Cute Dress Industry Limited

31st October 2018

Design Report required to be reviewed by Accord

Retrofitted beam layout of 1st floor

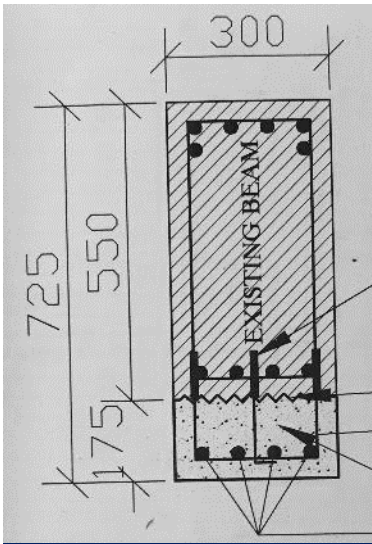
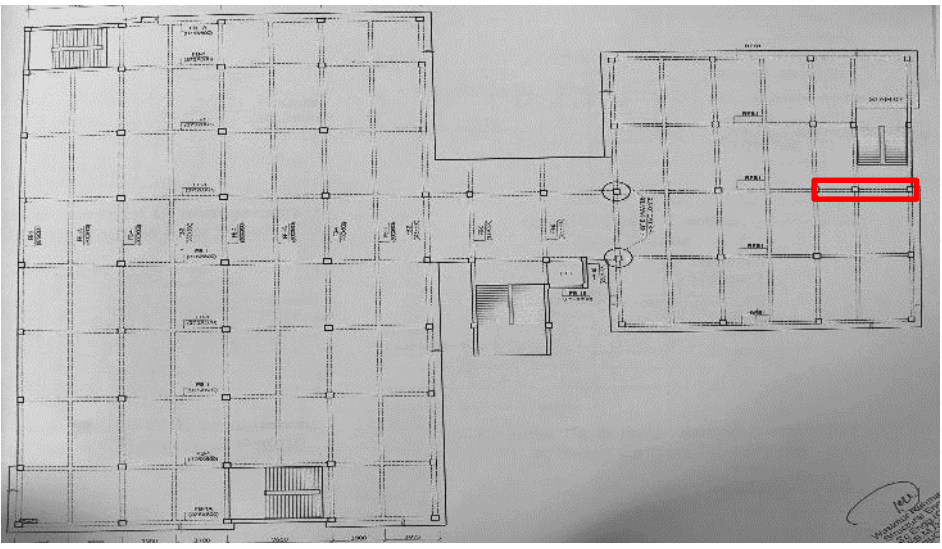
According to the design report, some beams were required to be retrofitted. But onsite, the retrofitted beams layout did not match with drawing. Factory is required to revise the design report as per on site condition.

Roof beam layout

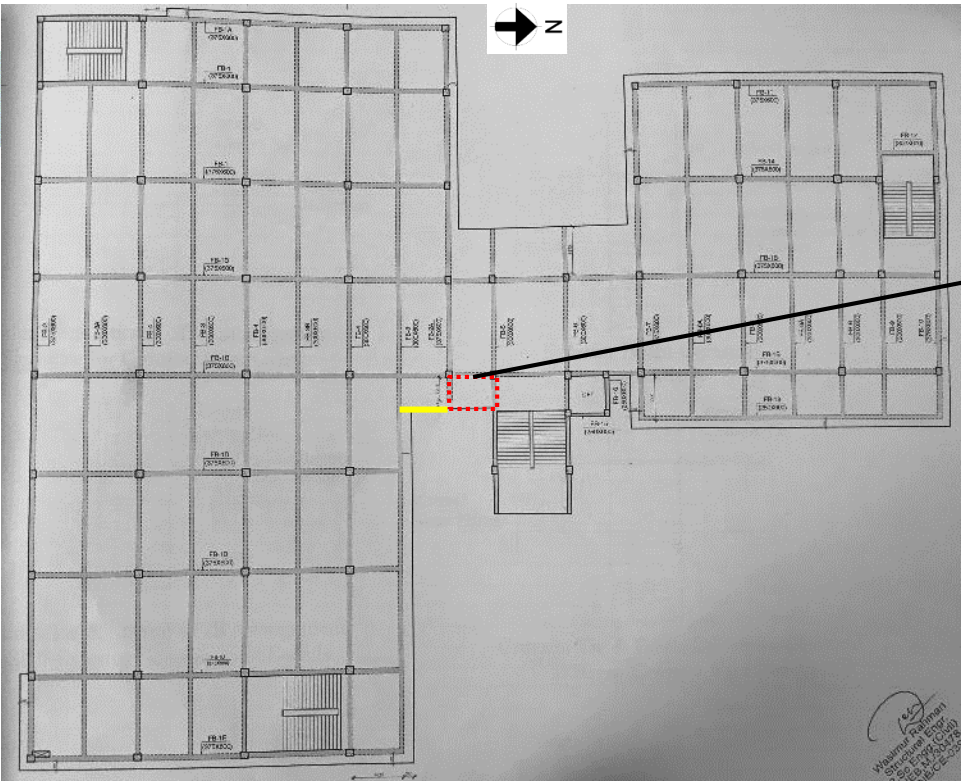
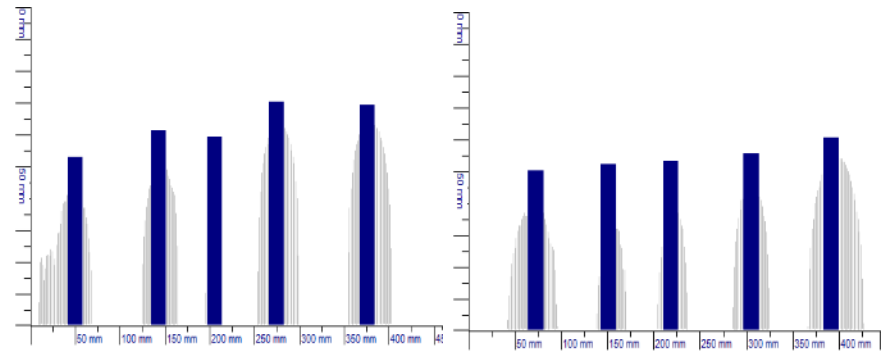
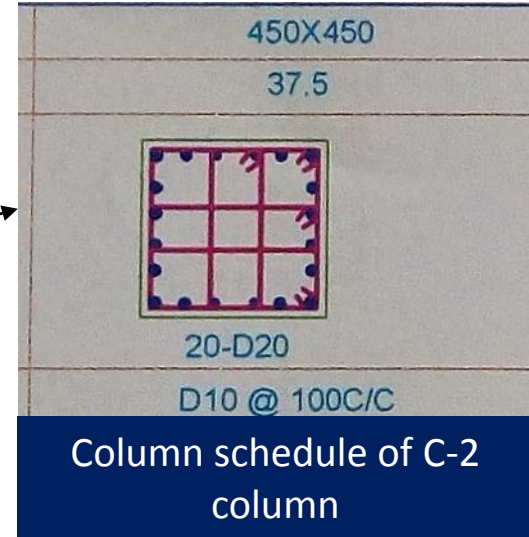
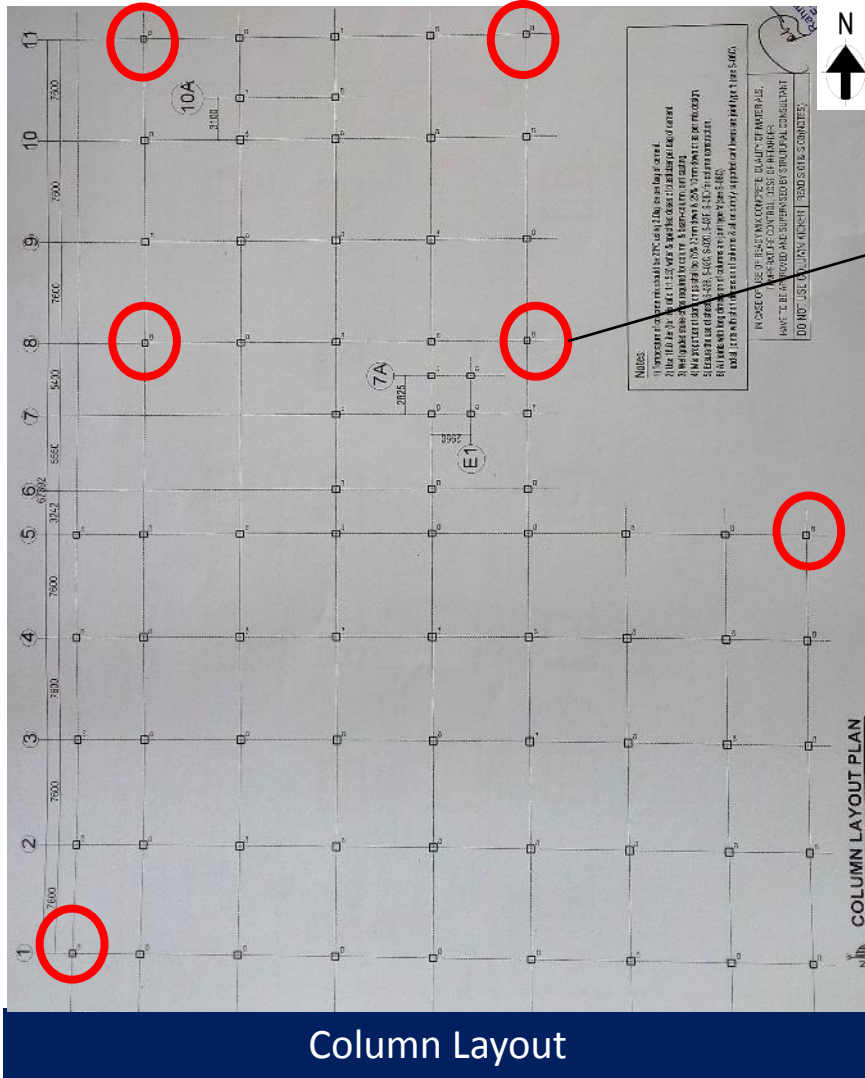
The red marked zone on floor plan, the slab was not present on site. Also, one new beam was found which was marked as yellow

Factory is required to produce accurate as-built drawings reflecting actual on site condition.

Column schedule of C-4 column

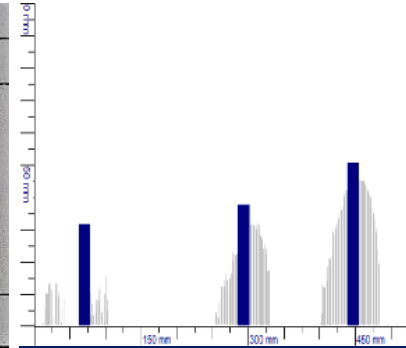
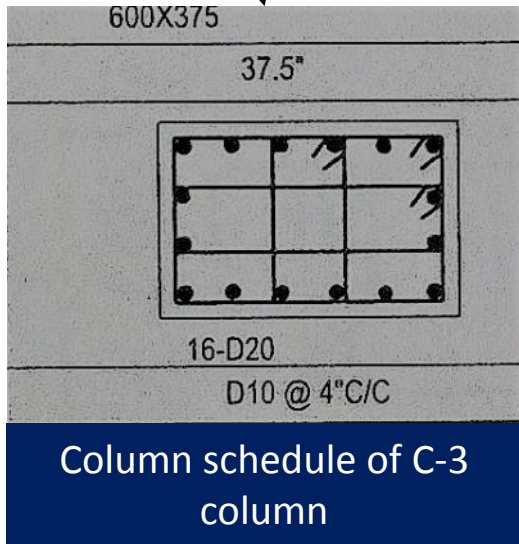
3 rebars were found in short direction of C4 columns instead of 4 rebars

Column schedule of C-3 column

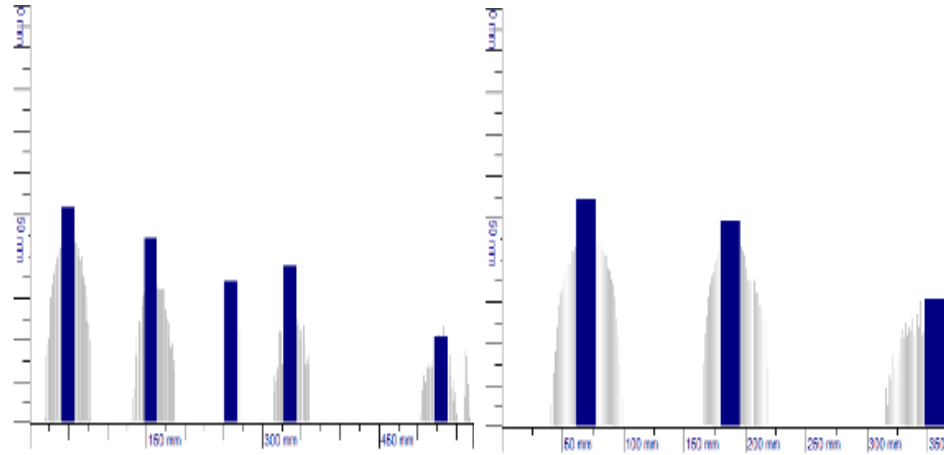
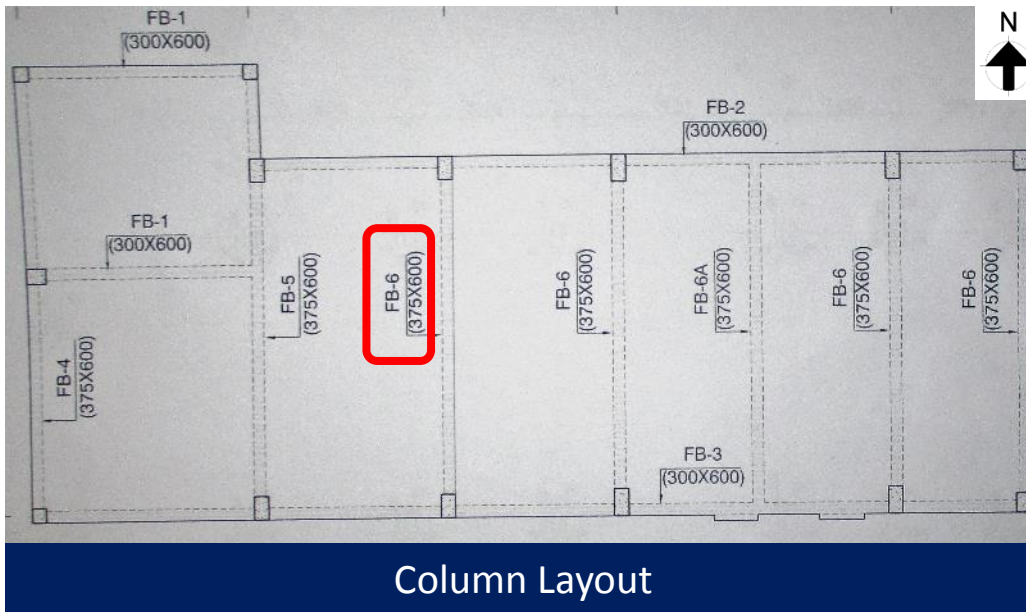
12 nos. Rebars (5x3) were found in C-3 column instead of 16 nos. rebars

Down stand depth of beam was measured 475 mm. If flat slab depth was considered as 200 mm as per as-built drawing then total depth of beam will be 675 mm instead of 600mm which was shown in as-built drawing. But if beam was 600mm then the slab thickness is 125mm. In this situation, the depth of slab is required to be ensured.
